FCC Class II Permissive Change Request Letter

RE: FCC Permissive II Change Request for Company: Guangdong Wangjia Intelligent Robot Co., Ltd.
FCC ID: 2AVYJ-J050A

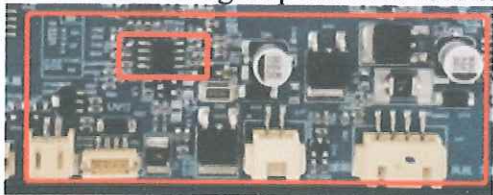
Remove the following gyroscope module, which functions to control EUT walking speed and Angle.

The added vertical 4P terminal and 2P seat have the same function, both are used for UVC-LED power supply, only one more UVC-LED is supported.

Add the following chip which is used to record the wheel speed.

Original PCB

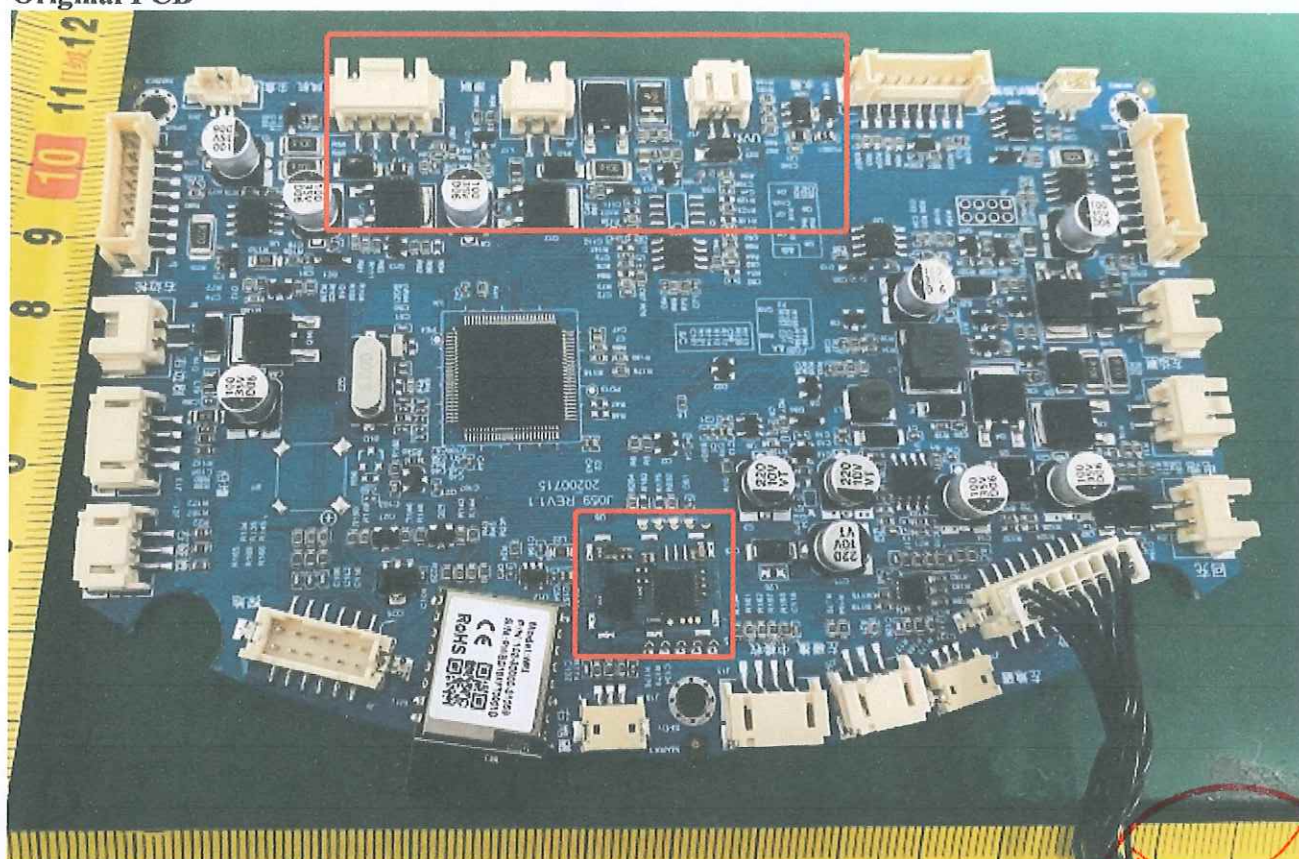
Part of PCB circuit, motor, adapter, battery and model have been changed, would not affect RF Performance, specification, output, etc. The RF circuit has not been changed.

The PCB changes are as follows:
